Access Compliance Report Public Rights-of-Way (Curb Ramps)

Main Street: RAINBOW_DR		Cross Street: HICKORY_BRANCH_RD		Location:	SE
ADA ID: RPAT211109105512	Ramp Type: Type 4 - Parallel	Initial Pass/Fail: Fail	Overall Compliance: No	Severity Score:	2
Codes/Mitigation Info/Possible Solution			Field Measurements/Component Compliance

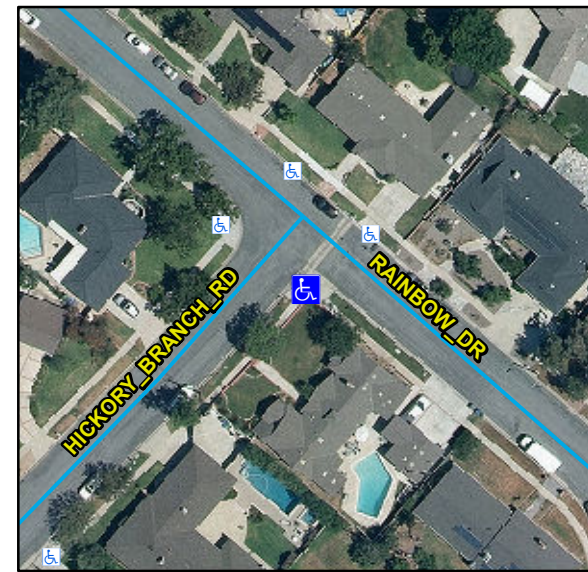
Compliance	Description	Data	Compliance	Description	Data
N/A	Ramp Length LT (in)	115	N/A	Ramp Length RT (in)	110
Yes	Ramp Width LT (in)	86	Yes	Ramp Width RT (in)	80
Yes	Ramp Run Slope LT (%)	6.5	Yes	Ramp Run Slope RT (%)	6.7
No	Ramp Cross Slope LT (%)	2.9	No	Ramp Cross Slope RT (%)	2.2
N/A	Landing Present	N/A	N/A	DWS Provided	N/A
N/A	Landing Length (in)	N/A	N/A	DWS Contrast	N/A
N/A	Landing Width (in)	N/A	N/A	DWS Length (in)	N/A
N/A	Landing Run Slope (%)	N/A	N/A	DWS Full Width	N/A
N/A	Landing Cross Slope (%)	N/A		DWS Offset Type	N/A
N/A	Landing Movement Obstructed?	N/A	N/A	DWS Offset Left (in)	N/A
	Landing Movement Type	N/A	N/A	DWS Offset Right (in)	N/A
N/A	Landing Shared	N/A			
N/A	Clear Space	Yes			
N/A	Clear Space To Crosswalk (in)	N/A			
N/A	Marked Crosswalk 1	No	N/A	Marked Crosswalk 2	No
	Crossing 1 Direction	NE		Crossing 2 Direction	NW
N/A	Marked Crosswalk 1 Width (in)	N/A		Marked Crosswalk 2 Width (in)	N/A

Remove & Replace Curb Ramp With Two New Directional Ramps or Equivalent.

R304.5.3, STD 1115
